# Access Compliance Report

## Public Rights-of-Way

Intersection ID: 28228	Main Street: LINDRICK_LN	Cross Street: TOM_SHORT_RD	Location: SW
ADA ID: 7899CE2440BF	Ramp Type: BlendTrans1	Initial Pass/Fail: Fail	Overall Compliance: No
		Severity Score: 10

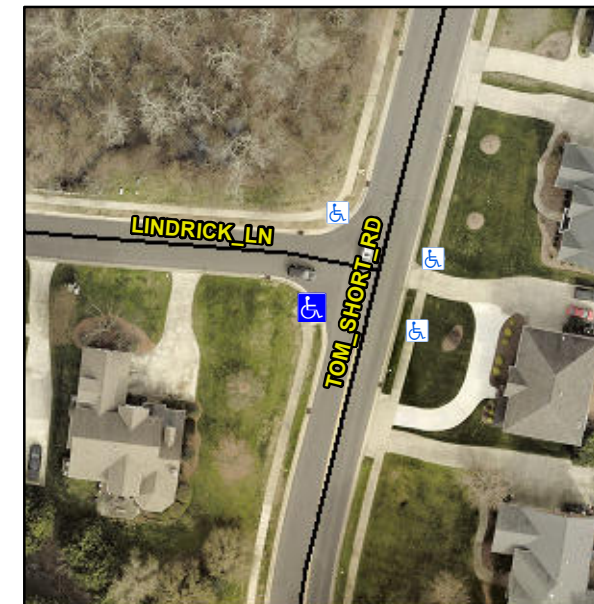
**CURB LIP 1.0**

**R304.5.1, R304.5.3**

Compliance	Description	Data	Compliance	Description	Data
N/A	Ramp Length (in)	58.5	Yes	BlendTrans Slope (%)	4.4
No	Ramp Width (in)	39.0	No	BlendTrans XSlope (%)	4.1
N/A	Flare Type LT	N/A	N/A	Flare Type RT	N/A
N/A	Flare Slope LT (%)	N/A	N/A	Flare Slope RT (%)	N/A
N/A	Flare Traversable LT?	N/A	N/A	Flare Traversable RT?	N/A
N/A	Landing Length (in)	N/A	N/A	DWS Provided?	N/A
N/A	Landing Width (in)	N/A	N/A	DWS Contrast?	N/A
N/A	Landing Slope (%)	N/A	N/A	DWS Length (in)	N/A
N/A	Landing X Slope (%)	N/A	N/A	DWS Full Width?	N/A
N/A	Landing Curb? (Y/N)	N/A	N/A	DWS Offset (in)	N/A
N/A	Shared Landing?	N/A			
N/A	Gutter Ponding?	N/A	N/A	Gutter Slope (%)	N/A
N/A	Gutter Lip Ht (in)	N/A	N/A	Gutter X Slope (%)	N/A
N/A	Painted X Walk1?	No	N/A	Painted X Walk2?	No
	X Walk 1 Direction	To SE		X Walk 2 Direction	To NE
	X Walk 1 Width (in)	N/A		X Walk 2 Width (in)	N/A
	X Walk 1 Slope (%)	2.3		X Walk 2 Slope (%)	5.1
	X Walk 1 X Slope (%)	4.4		X Walk 2 X Slope (%)	0.9

**Remove & Replace Curb Ramp With Two New Directional Ramps or Equivalent.**
